Serial No.: 09/904,387

Slide For Sorting Machine For:

RESPONSE TO OFFICE ACTION

FIG.3

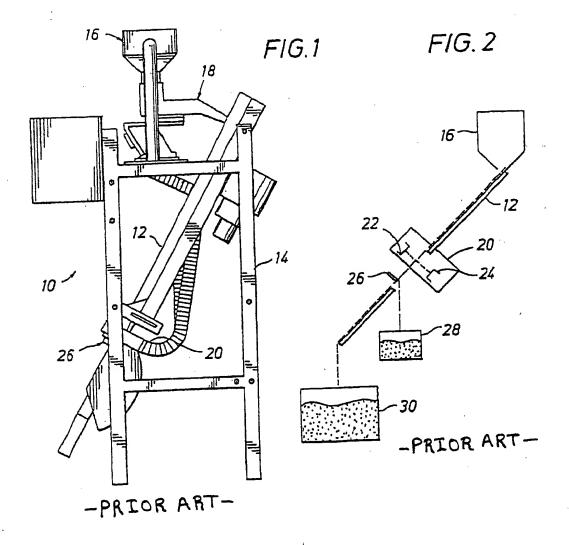
The applicant offers one (1) sheet of substitute drawings to include designations of --Prior Art-- on Figs. 1 and 2. Figs. 3 and 4 each depict a representative product guide 50. Product guide 50 is an aspect of the present invention, so marking of Figs. 3 and 4 as Prior Art has been deferred pending action on this response.

The applicant offers substitute drawings for Figs. 1 and 2 to include designations of --Prior Art--. Figs. 3 and 4 each depict a representative product guide 50. Product guide 50 is an aspect of the present invention, so marking of Figs. 3 and 4 as Prior Art has been deferred pending action on this response.
